**PLANNED UNIT DEVELOPMENT &
PLANNING APPROVAL STAFF REPORT****Date: May 3, 2007**

<u>NAME</u>	MacMae Venture, LLC & Georgetown Partners, LLC
<u>LOCATION</u>	2789 MacMae Drive (South terminus of MacMae Drive)
<u>CITY COUNCIL DISTRICT</u>	District 5
<u>PRESENT ZONING</u>	B-3, Community Business District
<u>AREA OF PROPERTY</u>	4.4 acres \pm
<u>CONTEMPLATED USE</u>	Planning Approval to allow heavy distribution (gross floor area more than 40,000 square feet) in a B-3, Community Business District, and Planned Unit Development Approval to allow shared access and parking between two building sites.
<u>TIME SCHEDULE FOR DEVELOPMENT</u>	Immediate
<u>ENGINEERING COMMENTS</u>	Show limits of AE flood plain. Any lots in AE flood plain should have the minimum finished floor elevation shown on each lot. No detention allowed in AE flood plain. Must comply with all storm water and flood control ordinances. Any work performed in the right of way will require a right of way permit.
<u>TRAFFIC ENGINEERING COMMENTS</u>	Driveway number, size, location, and design to be approved by Traffic Engineering and conform to AASHTO standards.

SITE PLAN

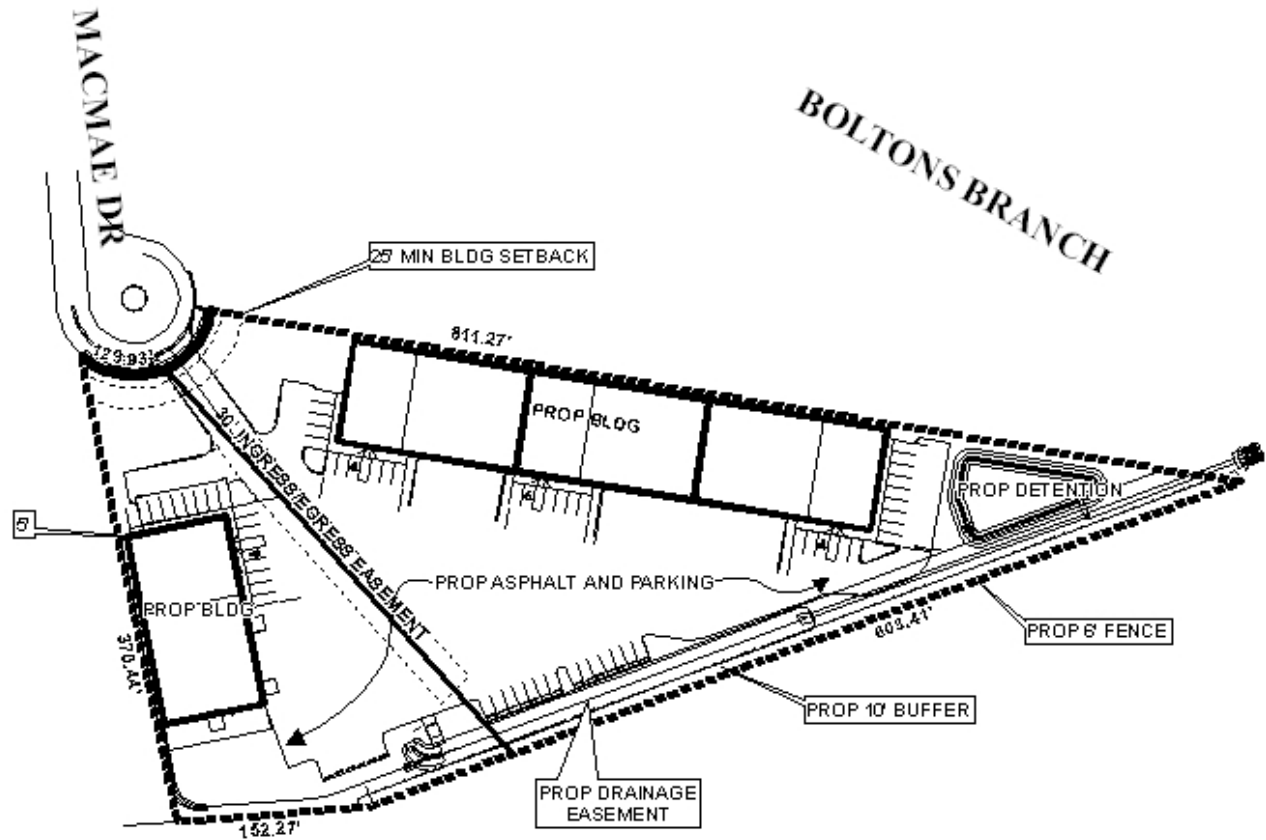
The site plan depicts two buildings, one containing 12,000 square feet \pm , and the other containing 33,600 square feet \pm in three separate spaces. Access, parking and storm water drainage and detention are shared between the buildings. A 10-foot wide buffer strip is proposed where the site abuts existing residences. The development will have a total of 16,960 square feet \pm of office space and 28,620 square feet \pm of warehouse space. A total of 19 warehouse employees are proposed, thus a minimum of 64 parking spaces would be required to serve the office and warehouse areas: 67 spaces are provided. It should be noted that the parking tally calculations on the site plan are not correct.

A landscape site plan has been provided to show compliance with the tree and landscaping requirements of the Zoning Ordinance. The overall size of the site, 4.4 acres \pm , requires a minimum landscape area of 23,184 square feet to meet the 12% landscape area requirement of Section 64-4.3.a. of the Zoning Ordinance: the site plan apparently depicts 35,501 square feet, well in excess of the minimum requirements. The landscape site plan also shows that some of the existing trees on the site will be retained for credits towards meeting the tree requirements. It should be noted that any trees that are used for credit, but that subsequently die, must be replaced. It should also be pointed out that the 10-foot wide buffer strip along the South property, adjacent to existing residences, should be kept either in a natural state, or augmented as necessary to provide an effective buffer. Finally, it appears that additional understory trees will be required in order to comply with Section 64-4.E.3.b.(1). *"Parking lot requirements."*

A sidewalk is depicted in the right-of-way where the site abuts the cul-de-sac of MacMae Drive. Construction of the sidewalk will be required unless a Sidewalk Waiver application is submitted to and approved by the Planning Commission.

Section 64-6. of the Zoning Ordinance requires that lighting be provided for off-street parking facilities containing more than ten spaces, if the parking facilities will be used after dark. If lighting of the building or parking area is proposed, the lighting must fully comply with Sections 64-4.A.2. and 64-6.A.3.c. of the Zoning Ordinance; specifically, lighting for the site should be designed and placed so that it does not shine onto residential properties (use of “full cut-off” fixtures).

Finally, the legal description on the site plan refers to “Lot 3 and 4, Willard Subdivision, First Addition.” The subdivision plat described in the legal description requires a 75-foot buffer strip where the lots abut the residences in the Belvedere Park Subdivision. Therefore the development, as proposed, is not possible until the “Willard Court” plat approved at the April 19, 2007 meeting of the Planning Commission is recorded, as it only requires a 10-foot buffer strip, as proposed by this application. The legal description on the site plan should then be updated to reflect the newly recorded plat.

- 4) correction of the parking calculations on the site plan;
- 5) revision of the site plan to fully comply with the tree and landscaping requirements of the Zoning Ordinance, including the provision of additional understory trees required by Section 64-4.E.3.b.(1). *Parking lot requirements*, if necessary;

- 6) placement of a note on the site plan stating that the 10-foot buffer area shall be landscaped or left in its natural state;
- 7) compliance with the site and parking area lighting requirements of Sections 64-4.A.2. and 64-6.A.3.c. of the Zoning Ordinance;

- 8) provision of the 6-foot high privacy fence, as depicted on the site plan;
- 9) provision of two (2) revised site plans (one for Planning Approval, one for PUD approval) to the Planning Section of Urban Development prior to the request of building or site development permits; and
